**CITY OF NEWTON**

**INTER-OFFICE CORRESPONDENCE**

SUBJECT: **Administrative Site Plan Review**  
**Lasell College Rockwell Residence Hall**

Figure 4. Dorm site from Forest Rd. , looking across athletic field

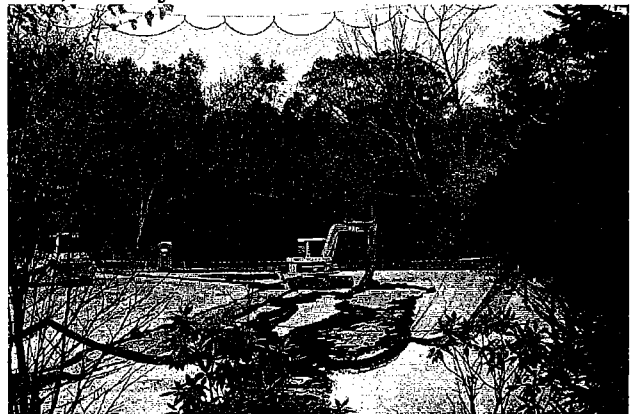
Forest Avenue sits a few feet below the grade of the proposed dormitory and Grellier Field. *The Planning Department requested that the College include additional trees on its plans for the edges of its campus along Forest and Aspen Avenues, to provide screening for abutters. The College has since provided an updated landscape plan to satisfy this request.*

**Figure 5. Bragdon Hall, corner of Woodland Ave. and Grove St.**

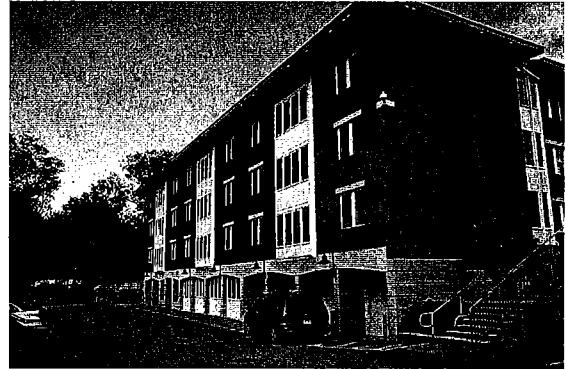
The Planning Department notes that Rockwell Hall, as proposed, does not bear any relationship to the adjacent historic structures. In other parts of the Lasell Campus, more care was taken to add architectural detailing, in keeping with the neighborhood, to the design of a new structure. For example, new construction on Bragdon Hill features gabled ends, variation in the exterior materials, and more detailed fenestration.

These examples were constructed ***before*** the creation of the Auburndale Historic District. ***Regardless of the presence of the Historic District, the Planning***

***Department would recommend that Lasell College look for opportunities to improve the architecture of the proposed residence hall.***
